Permit Number: 090451

This is to certify that YEE CHEUNGLUI / Robert R...
has permission to Remodeling of 1st floor unit in unit build...
AT 17 CODMAN ST CE 129 G011001

City of Portland, Maine - Building or Use Permit Application

Past Use: 3 Unit Residential	Proposed Use: 3 Unit Residential - Remodeling of 1st floor unit in 3 unit building	Permit Fee: \$120.00	Cost of Work: \$10,000.00	CEO District: 4
Proposed Project Description: Remodeling of 1st floor unit in 3 unit building		FIRE DEPT: <input checked="" type="checkbox"/> Approved <input type="checkbox"/> Denied * See Conditions	INSPECTION: Use Group: R-2 Type: SB IBL-2003	
		Signature: <i>KB</i>	Signature: <i>JMB 6/1/09</i>	
PEDESTRIAN ACTIVITIES DISTRICT (P.A.D.)				
Action: <input type="checkbox"/> Approved <input type="checkbox"/> Approved w/Conditions <input type="checkbox"/> Denied				
Signature: _____ Date: _____

FIRST FLOOR

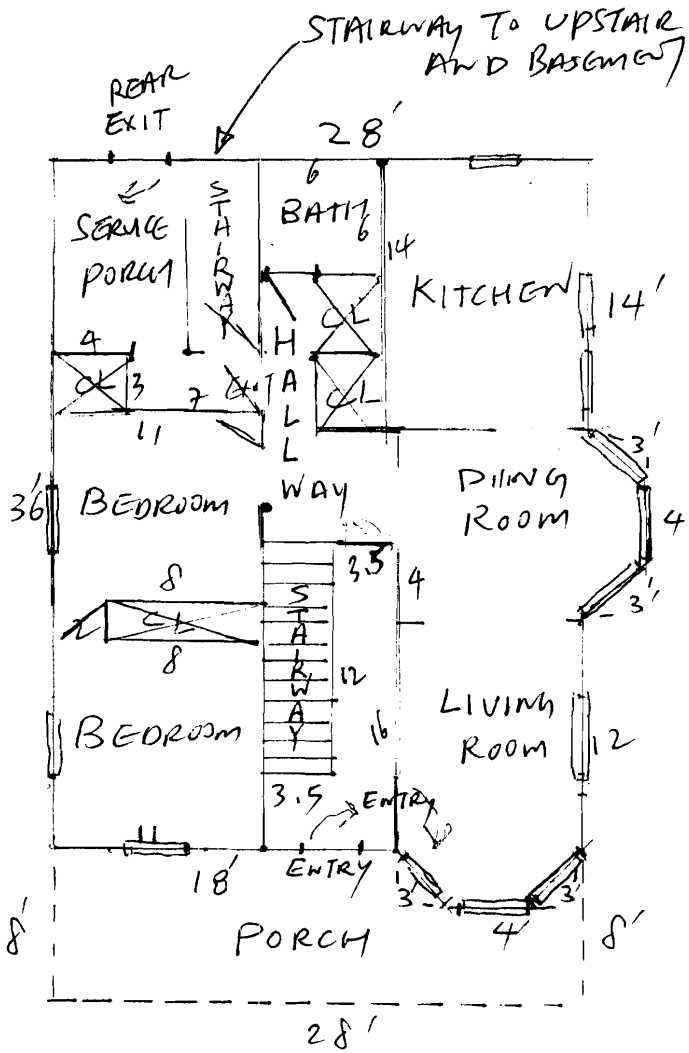
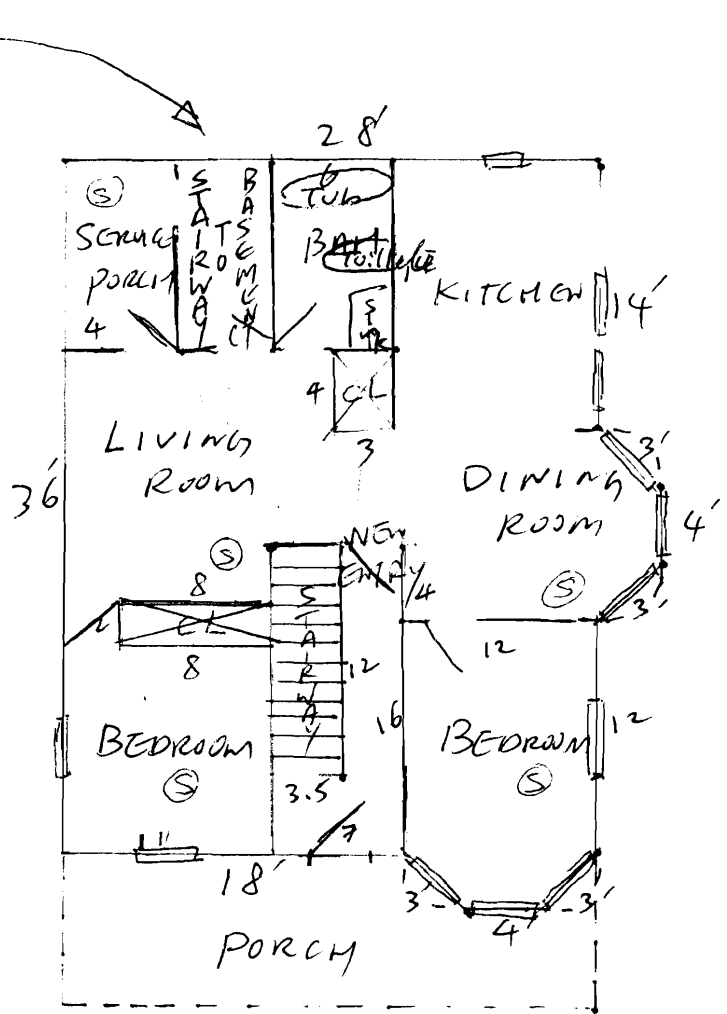
need (2) layers 5/8" type X or
ceiling & corner studs

Box in recessed lighting

- 1) All penetrations between dwelling units and dwelling units and common areas shall be protected with approved firestop materials, and recessed lighting/vent fixtures shall not reduce the (1 hour) required rating.
- 2) There must be a 2" clearance maintained between the chimney and any combustible material, with draft stopping per code at each level
- 3) Hardwired interconnected battery backup smoke detectors shall be installed in all bedrooms, protecting the bedrooms, and on every level.
- 4) Separate permits are required for any electrical, plumbing, sprinkler, fire alarm or HVAC or exhaust systems. Separate plans may need to be submitted for approval as a part of this process.
- 5) Application approval based upon information provided by applicant. Any deviation from approved plans requires separate review and approval prior to work.

5/29/2009-jmb: Owners # is not in service, left vcmg with contractor for detail on tub location and if a window is in the surround for tempered glazing. Also have emailed owner. Had several meetings with them at the counter for preliminary review.

8/24/09 - checked new framing & (2) 5/8" Type X ceiling
electrical plumbing tested & dc - no issues seen

OK to close-in,

6/1/2009-jmb: Received email response....per the owner there is no window
